ARCHITECTURAL REVIEW BOARD WORK SESSION AGENDA

Agenda Item: Architectural Review for DP#25-01, 535 Herndon Parkway

Subject: Architectural Review for DP #25-01, 535 Herndon Parkway

Subject: Discussion Item, proposed Special Exception (SE#25-02), 250 Spring Street

1 WEST ELEVATION
SCALE: 1/8" = 1'-0"

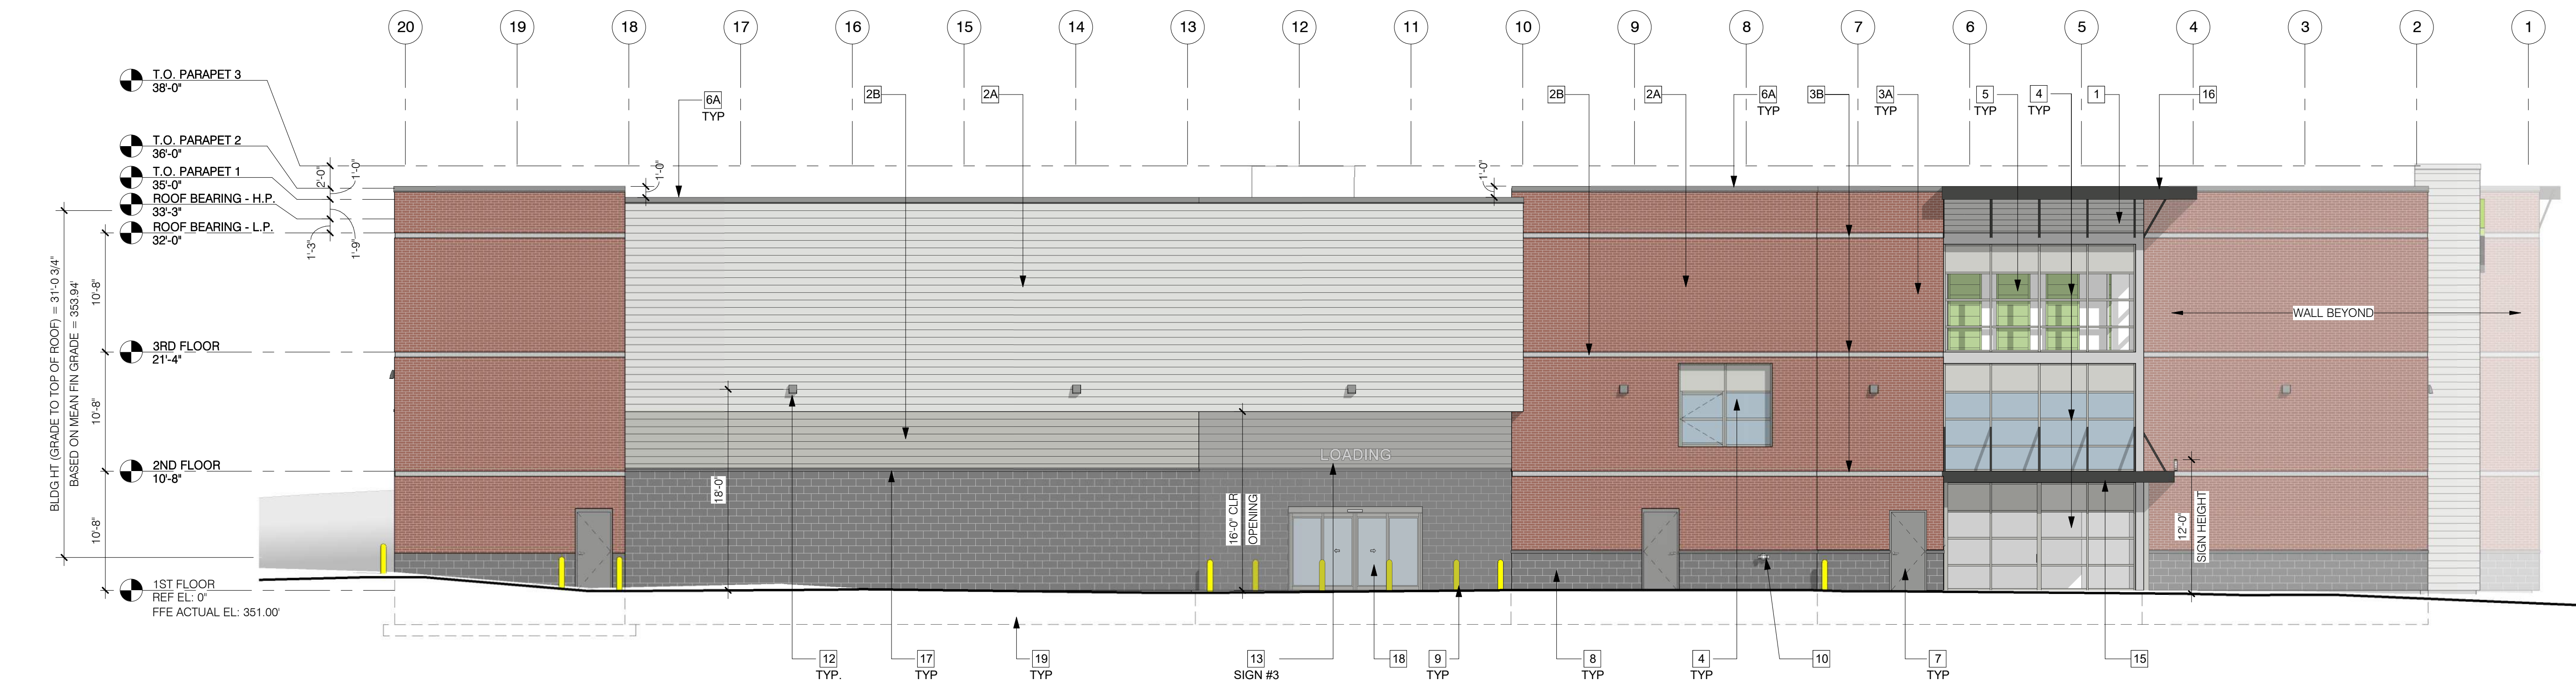
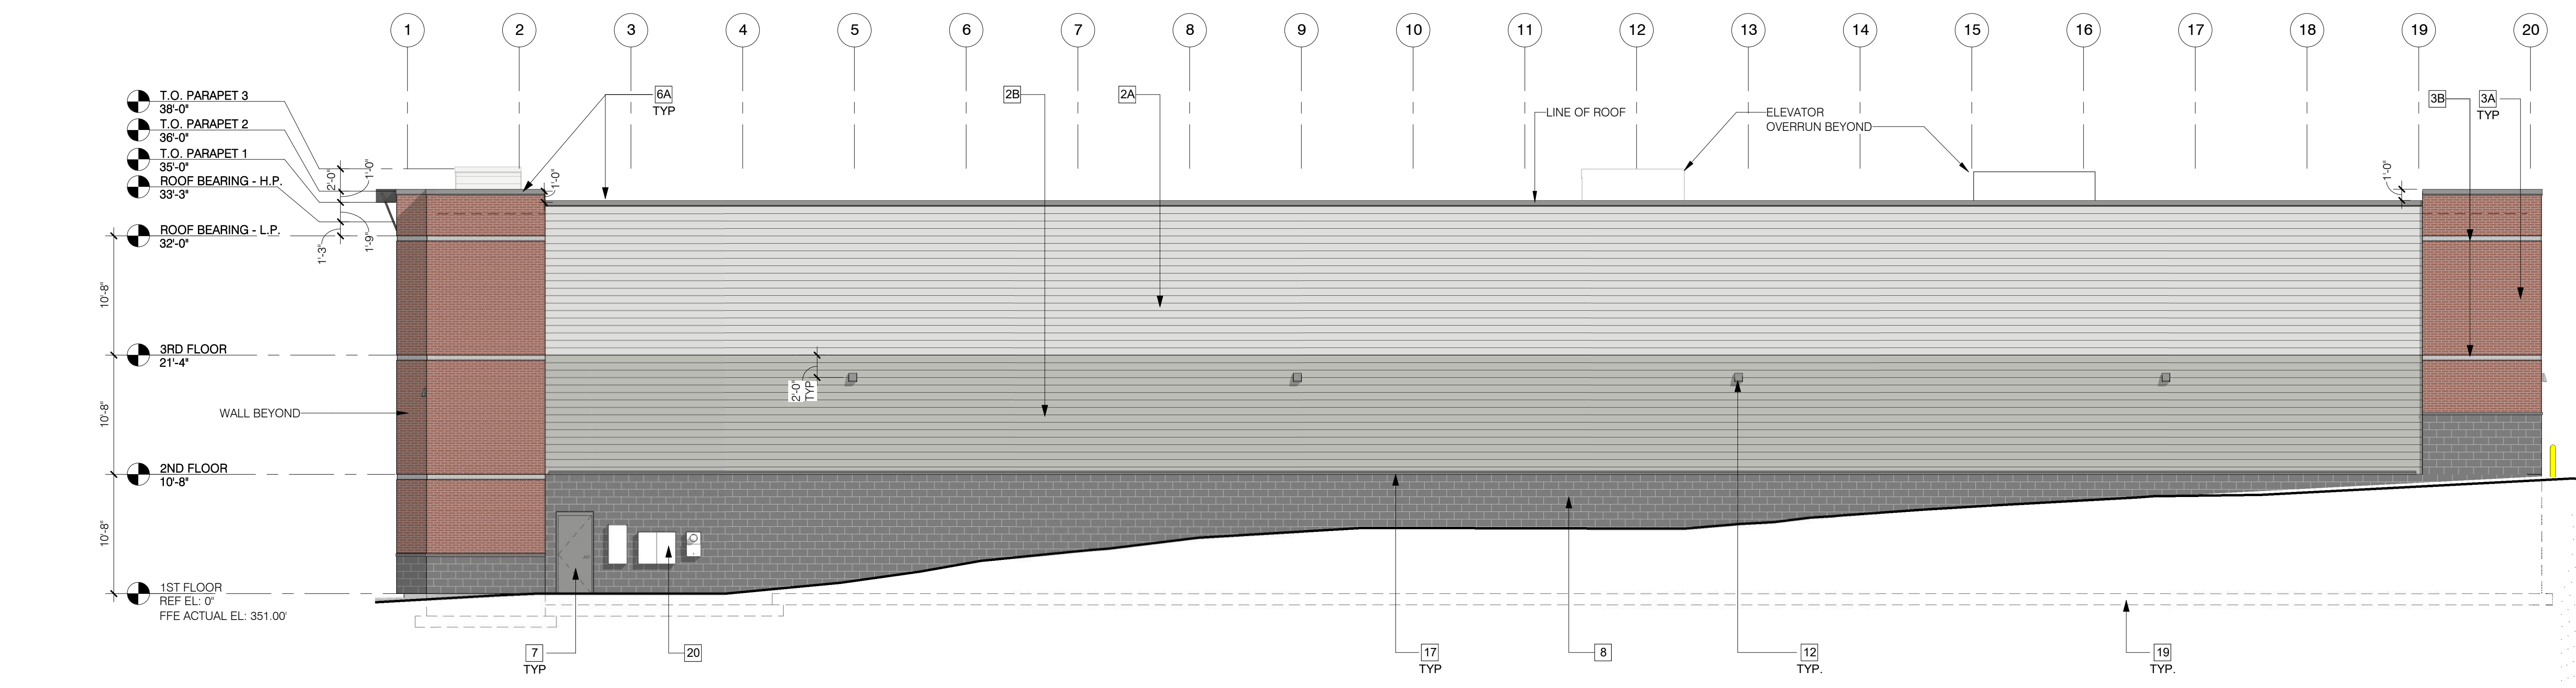
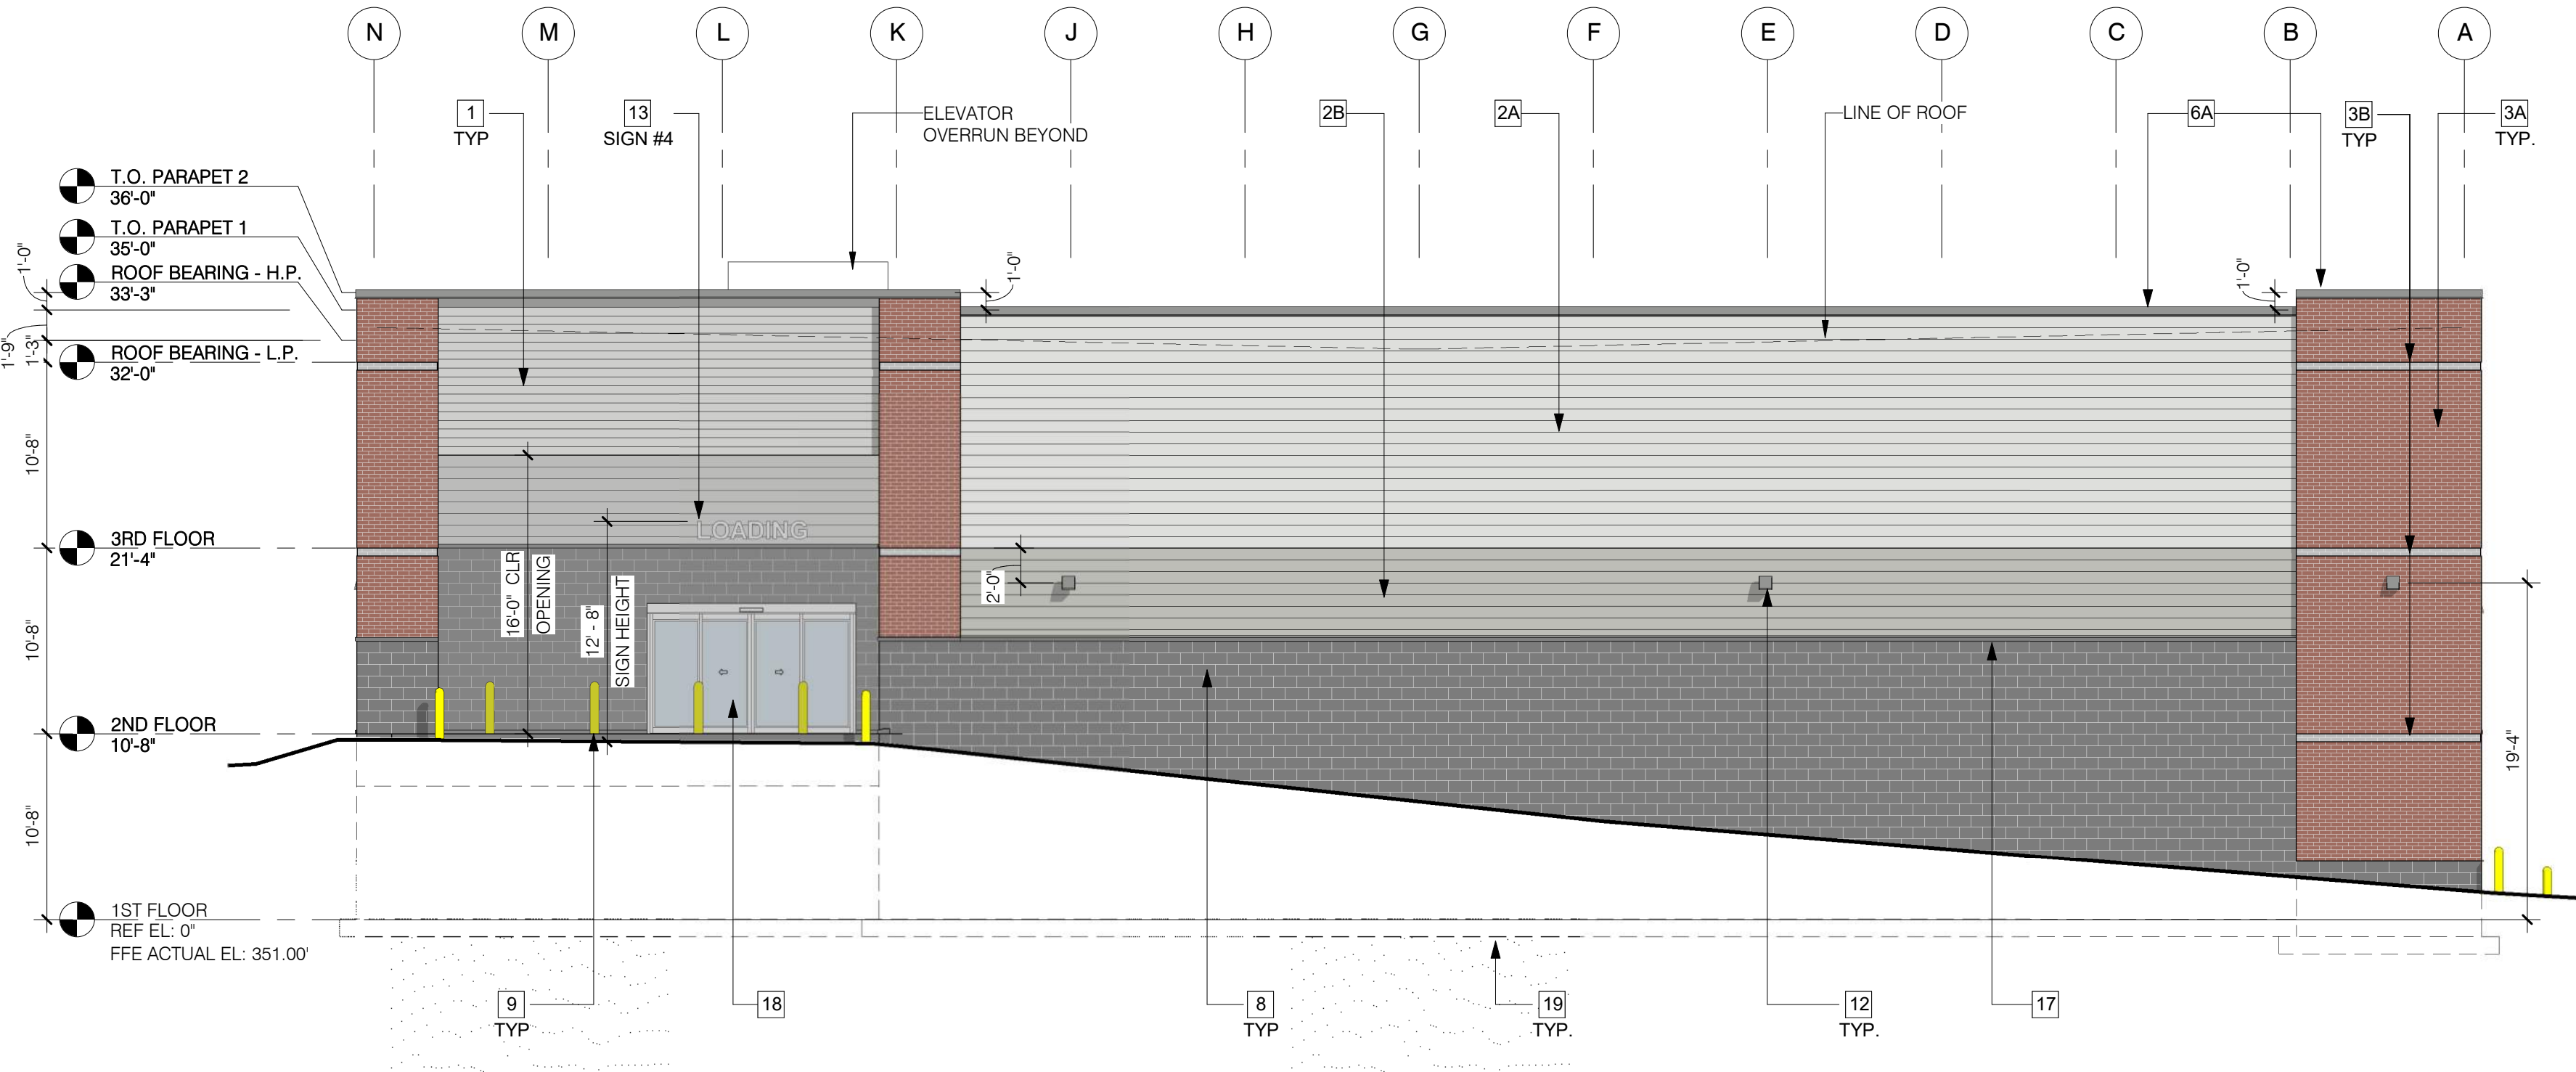
Suitability of the Overall Design (ACD Criterion 1): The current design features a mix of metal siding and masonry cladding. The south and west elevations are the most visible from the public right-of-way, and the applicant has included a higher concentration of masonry cladding on these elevations compared to the east and north portions of the building, which primarily feature metal siding boarded by red brick detailing primarily at the corners. The base of the building is faced with charcoal-gray Concrete Masonry Unit (CMU) blocks on all sides, but is of varying height on each elevation, partially in response to grade changes on the site.

The division of bays on the façade (south elevation) and the west elevation, each the most visible from the right-of-way, establishes a hierarchy between bays and presents a mostly cohesive design. Additional details will be needed to fully understand the articulation of the fenestration on the storefront at the southwest corner, as well as the bay of windows on the façade. Currently, the view of the façade rendered from the southeast corner appears to lack dimensionality in its articulation, but this may be due to the rendering itself rather than the intended design (*Figure 2*). The board should discuss if the notable difference in the overall detailing on the north and east elevations is appropriate given the limited visibility from the right-of-way. Furthermore, the materials provided do not contain information on the size or arrangement of the accompanying self-storage buildings behind the main office. The applicant should provide the board with a plan that shows their arrangement, as well as elevations for a typical building unit's design.

Architectural Harmony (Criterion 4): As discussed above, the two most public facing elevations (south and west) are extensively clad in masonry and the articulation and hierarchy of the massing along each elevation is highly resolved. In contrast, the east and north elevations feature large expanses of metal siding and do not have much articulation or hierarchy to break up the wall plane. These elevations have limited visibility from the right-of-way. The ARB should discuss whether this conforms to Criterion 4, which looks to ensure that the treatments for exterior walls of freestanding buildings are harmonious.
